# Historic Zoning Commission

October 16, 2025

# Case # HZ-25-54

## 203 Eveningside Drive

## Front Elevation Changes (East)

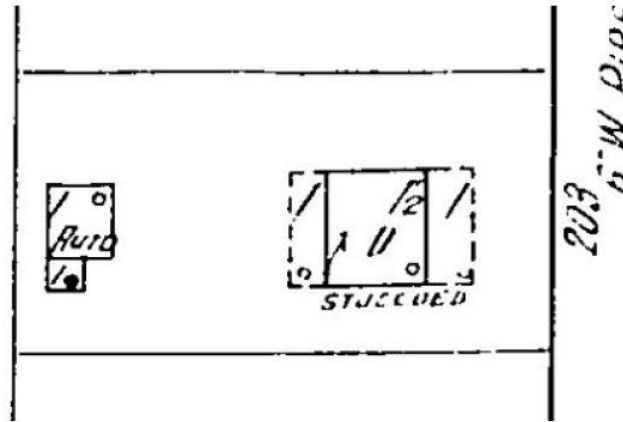
- 1: Change single window (left side) to triple window that mimics the original one to the right of the front door. The single window that is removed will relocate to the left elevation. New window to be wood clad, simulated divided lite.
- 2: Change dormer material from asbestos siding to real cedar shake.
- 3: Remove vinyl shutters from all windows and replace shutter on dormer only with wooden, operable style with dogs.
- 4: Replace existing metal chimney cap with clay cap that is more period correct.

5. Plastic or metal strip awnings or non-original shutters that detract from the character and appearance of the building should not be used.
6. **New window and door openings should not be introduced. The applicant is proposing to install multiple new door and window openings. Applicant is proposing a new front window on the front elevation that was previously an open porch and french doors on to the existing porch on the front elevation. Applicant is proposing two new windows on the east elevation at the rear and one new window on the south elevation at the rear.**

## Left Elevation Changes (South)

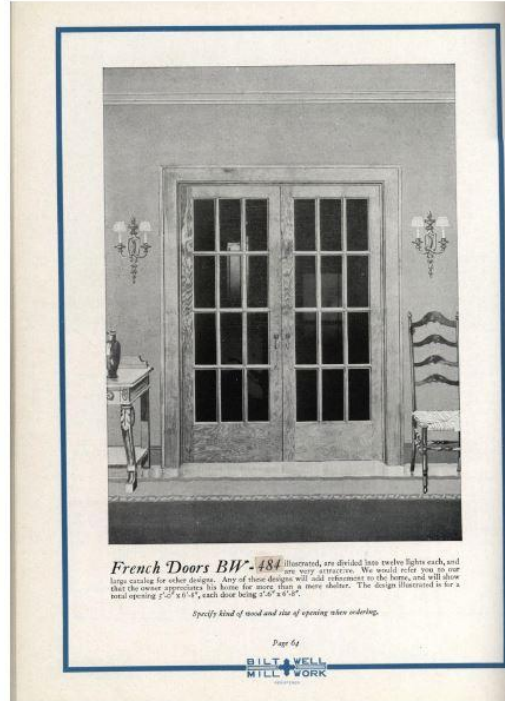
- 1: Change dormer material from asbestos siding to real cedar shake.
- 2: Single window relocated from the front moves to side of breakfast room (front right).
- 3: Remove 1960s railing and replace with wood balusters and 6"x6" wood columns.
- 4: Exchange center window position with right window position.

BACK ELEVATION

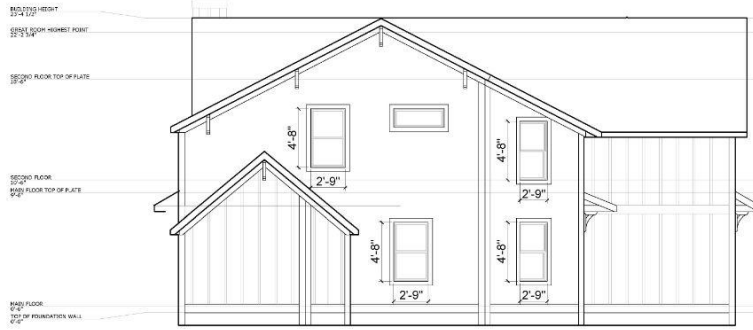
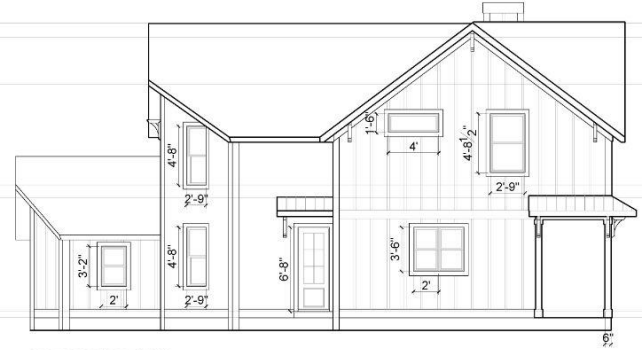
3. We remove the window on the back right and left side of the bump out and installed transom window on the back wall.

Not draw but we will do the handrails standard 36"to 42" hight with 2 x 2 spindles. We added a door coming off of the master to the covered deck.

**Windows:** Wood construction is preferred for windows, especially those on the fronts of buildings. However, the use of vinyl clad or aluminum windows is also acceptable as long as they follow proper proportions (see window guidelines). The use of dark anodized aluminum windows or storm windows is appropriate. **The window configuration has changed on the rear of the dwelling. One window is to be removed on the “right side elevation”, a transom window and door to the proposed rear deck has been added to the “back elevation.”**

sheet **A3.0**

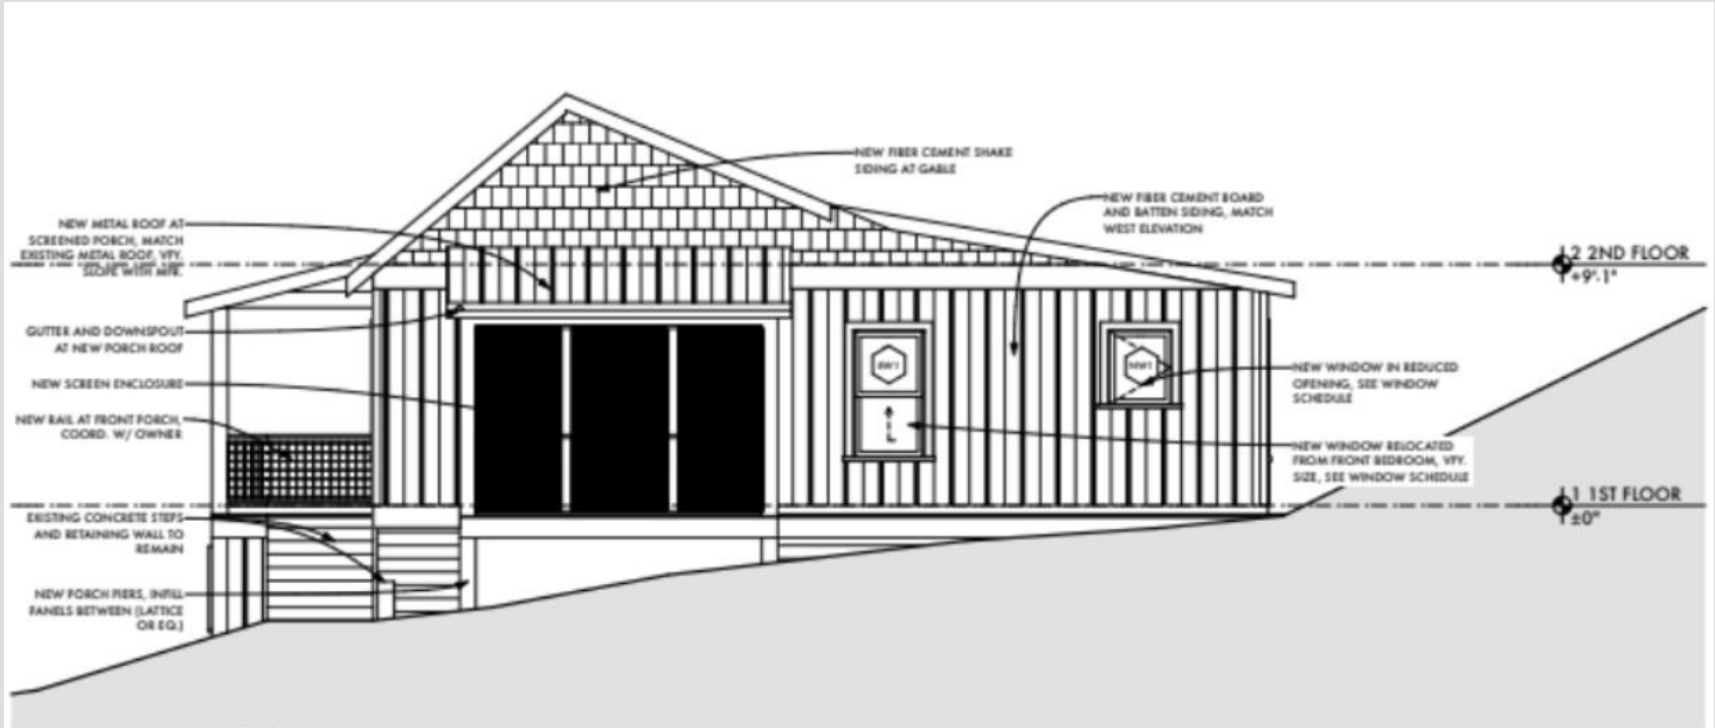
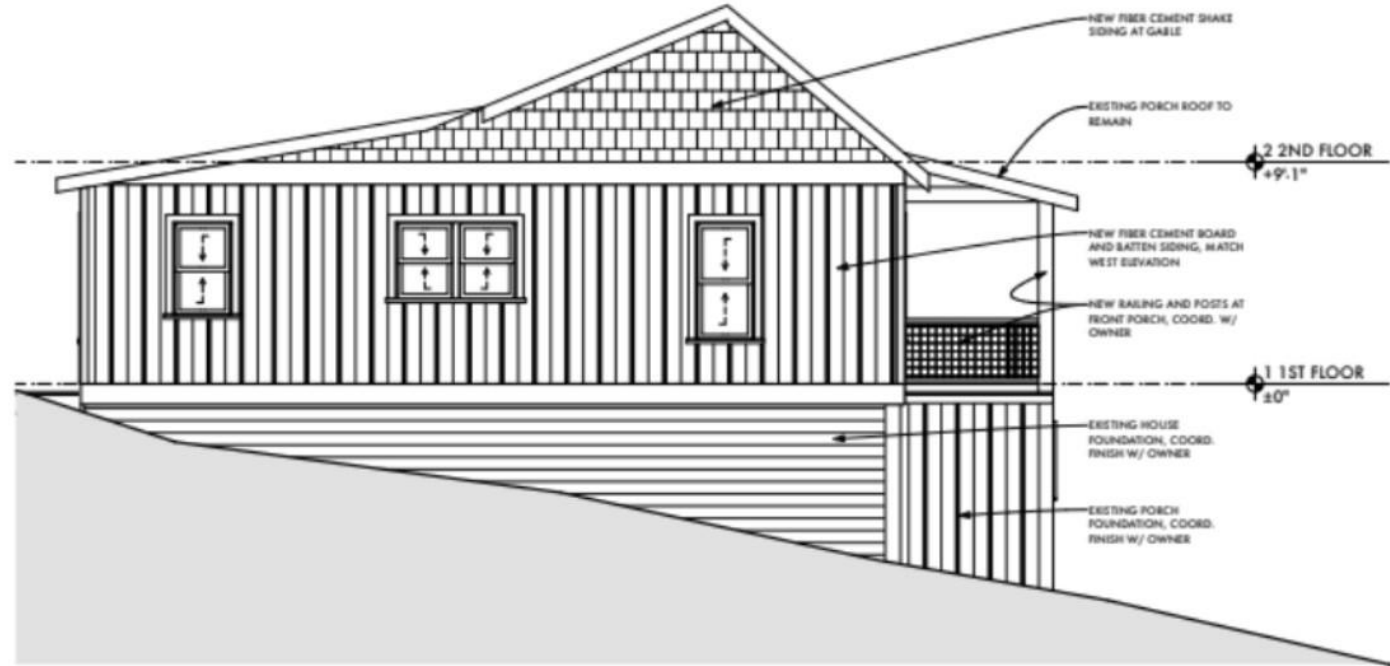
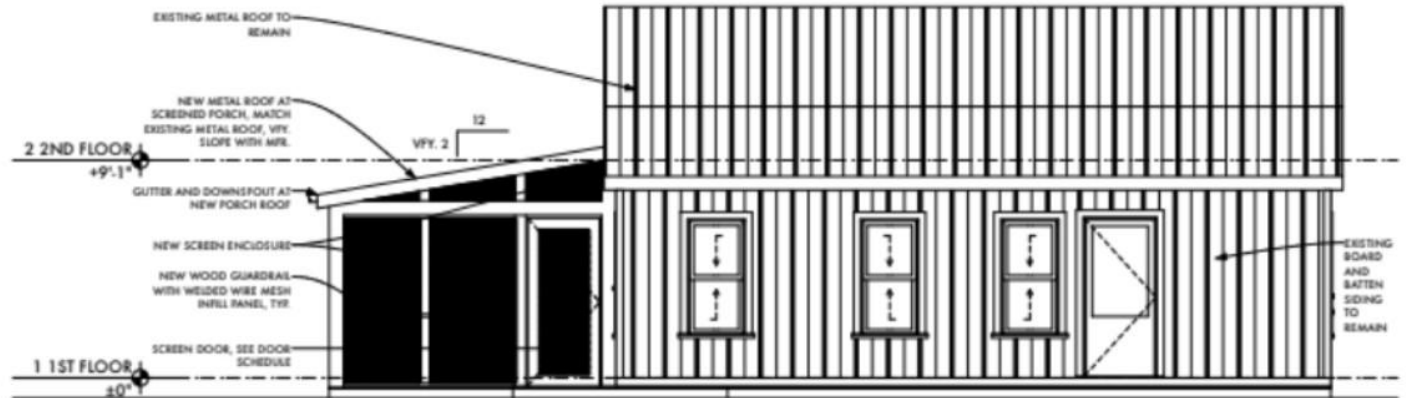
- B. Between existing piers should be filled in as traditional for the type and style of the house, generally with wood lattice framed panels; with brick of color, tooling, and mortar color appropriate for the period of the house, or with decorative vertical wood boards. **Applicant notes screening between piers of the screened porch. The drawings show solid panels.**

- C. Should not be concealed with concrete block, plywood panels, corrugated metal, or wood shingles. **Applicant notes screening between piers. The drawings show solid panels.**

- A. On front and side facades should be maintained in their original configuration and with original materials and detailing.
- B. Should not be removed if original. **The existing front porch columns may be a later addition or covered in modern material. The applicant is proposing to remove posts and balustrade and replace with wire railing and cedar posts. This is not compatible with the period of the dwelling.**

- A. Wood siding original to the building should be repaired rather than replaced only where necessary due to deterioration. **Applicant is proposing to remove the existing vinyl siding and replace it with fiber cement shingle and board and batten siding. Applicant to confirm if original wood siding is present underneath existing vinyl siding.**
